Hamsland, Horsted Keynes St Stephen's Church, Land to the South of

Land ownership and highway configuration at proposed site entrance

- This document reviews Rydon/RPS's updated Proposed Site Access, Visibility Splay drawing 1044-FA-203 Rev C which Rydon has submitted as Action Note 11, Appendix 5 (Ref: REP-2140-002e)

Rydon updated Rev C access proposals

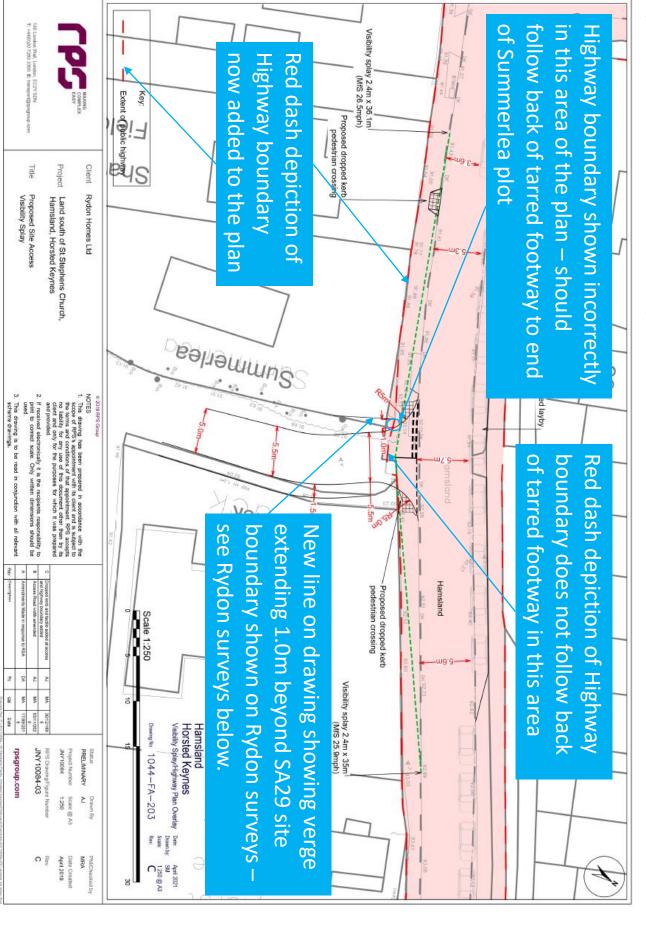
- Rev C (Action Note 11, Appendix 5) makes minor modifications to the access and introduces a critical additional line which appears to confirm that the site access needs additional land beyond that in Rydon's control.

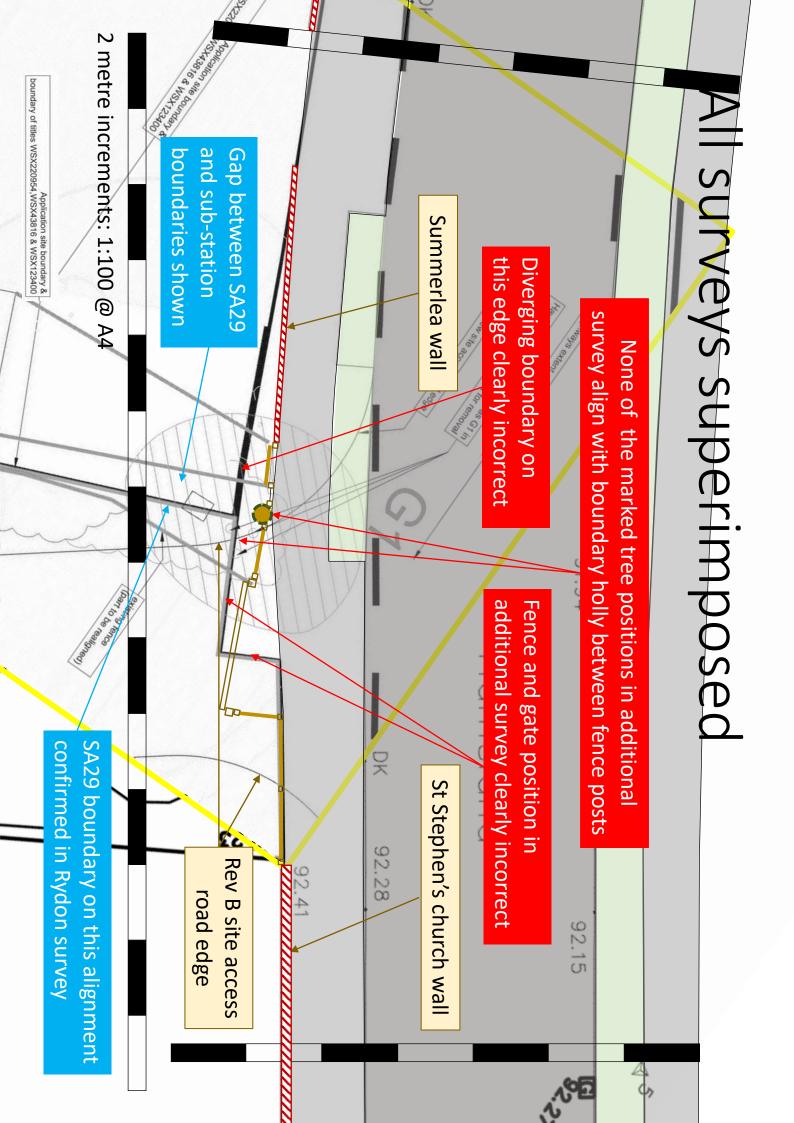
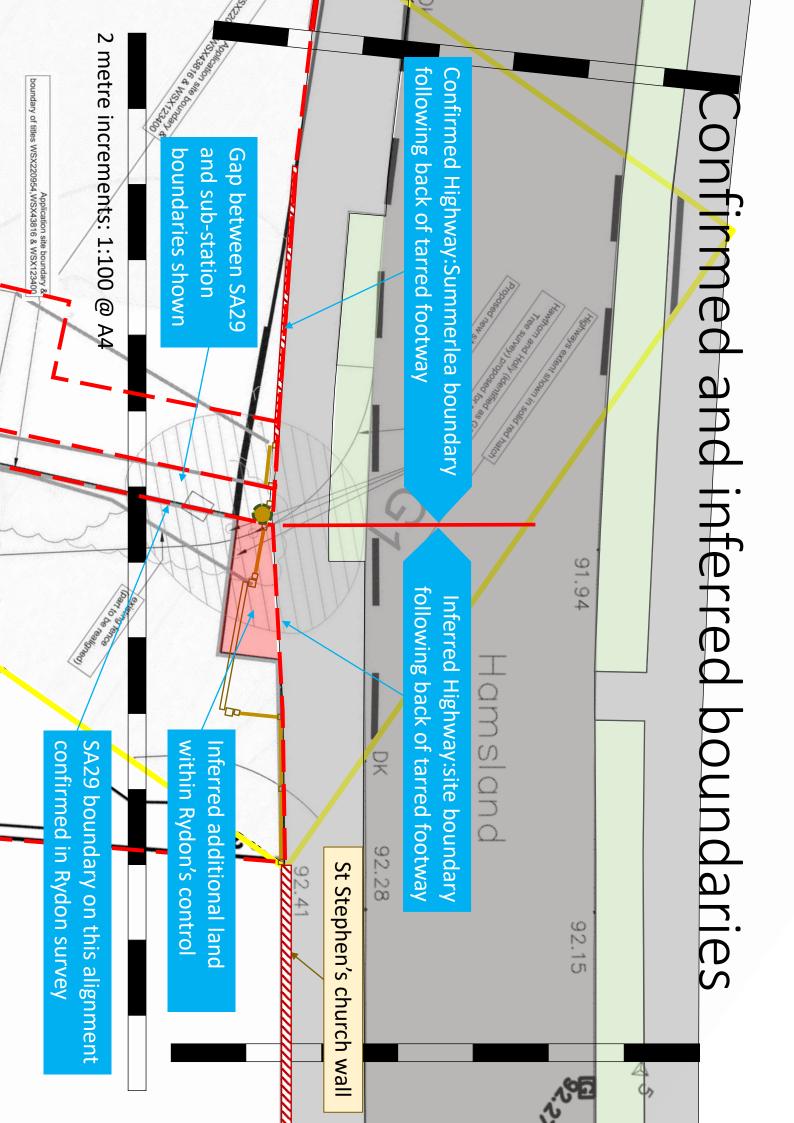
clashes with parked cars by up to c.0.5m 2 metre increments: 1:100 @ A4 and parked vans by up to c.0.9m 5.7m zone for refuse vehicle swept path Application site boundary boundary of titles WSX220954,WSX43816 & WSX1294 Rev Baccess proposals assessed 0.5m wide verge extends into beyond / on site boundary land beyond site boundary and removes holly tree 91.94 m_{V.}2 5.5m lay-by zone 2.0m wide 1.5m wide footpath width Stephen's Church wal restricted by end of St SA29 boundary on this alignment confirmed in Rydon survey 92.2 St Stephen's church wall

Traffic Signs Manual requires Give Way line to be tangential with kerb. 5.7m zone for refuse vehicle swept path appears to clash parked cars by up to c.0.5m and parked vans by up to c.0.9m

shown too far to the north

inaccurately, so lay-by

boundary and removes holly tree beyond / on site boundary ហ្វៀ 1.0m wide verge extends further into land beyond site

Up to 1m wide triangle of land now claimed by Rydon in Rev C to make the access work and to provide visibility for pedestrians

Land relied on by Rydon beyond its control to make the access work

Bellmouth has been moved south-west which has reduced width restriction on footpath

New line on Rev C drawing showing verge extending 1.0m beyond SA29 site boundary

Rydon updated Rev C access proposals

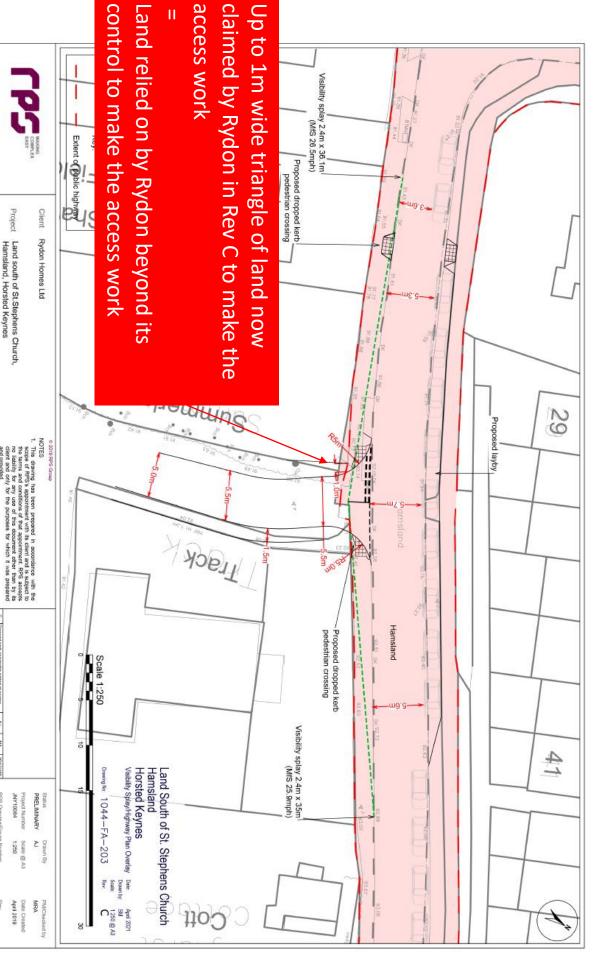
- This analysis has been drawn carefully to scale using Rydon's survey as a base to correct drafting errors evident in Drawing 1044-FA-203 Rev C. It demonstrates conclusively that Rydon:

- Can just provide acceptable visibility splays within the highway and/or on land in its control, albeit this may require X to be reduced to from 2.4m to 2.0m to avoid St Stephen's church land; but

- <u>Cannot</u> accommodate the bellmouth access, with a footpath to the east and a verge to the west, within the highway and/or on land in its control; and

- <u>Cannot</u> provide for the safe swept path of refuse vehicles entering and leaving the site without losing essential parking on Hamsland;
- a c.1m wide verge with adequate visibility for pedestrians within its control, in order to provide the bellmouth access and heightened concern that Rydon does not have control of the Each successive Revision of Drawing 1044-FA-203 has necessary land. In Revision C, Rydon appears to confirm this by introducing a claim tor a triangle of land that is not currently
